BUILDINGS ORDINANCE (Chapter 123)
(Section 35)

BUILDINGS ORDINANCE (CAP. 123)
Order by the Building Authority under section 24(1)

Order No. :	C/TC/001019/23/NT	Office of the Building Authority
BD Ref. :	EB/9024/90/803/H06/Hse23(WIP)	Buildings Department Headquarters,
To :	Owner(s) of NO.23 HIBISCUS PATH (HOUSE TYPE A5) PALM SPRINGS PHASE 1C YUEN LONG NEW TERRITORIES	North Tower, West Kowloon Government Offices, 11 Hoi Ting Road, Yau Ma Tei, Kowloon.
		Date : 31 March 2023

Plan Annexed to Order No. : C/TC/001019/23/NT
 此圖則附連於命令編號
 BD Ref. : EB/9024/90/803/H06/Hse23(WIP)
 檔案編號

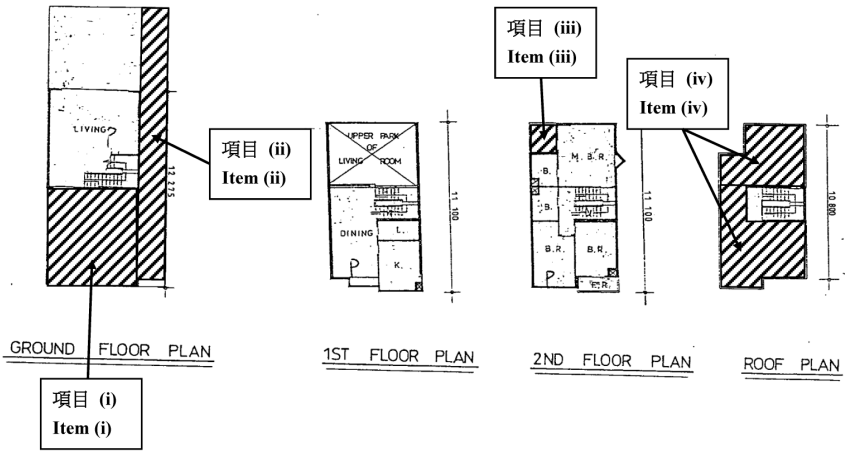
- (a) demolish the building works described under items (i) to (iv) below; and
- (b) reinstate the parts of the building so affected by the building works under items (i) to (iv) below in accordance with the plans approved by the Building Authority.
 - (i) Structure(s) erected on and over the G/F at the front;
 - (ii) Structure(s) erected on and over the yard on G/F;
 - (iii) Structure(s) erected on and over the flat roof on 2/F; and
 - (iv) Structure(s) erected on and over the roof.

(The locations of the building works described above are shown hatched-black on the plan annexed hereto, for the purpose of identification only.)

- (a) Items (i) to (iv) have been carried out without having first obtained from me the approval of building plans and consent for the commencement of such building works required by section 14 of the Buildings Ordinance.
- (b) As a result of item (i), Regulation 41(1) of the Building (Planning) Regulations, which requires the building to be provided with such means of escape in case of emergency as required by the intended use of the building, has been contravened.

2. You are required to commence the works ordered by me in paragraph 1 above within **30** days and complete such works within **60** days of the date of this order, all to the satisfaction of the Building Authority.
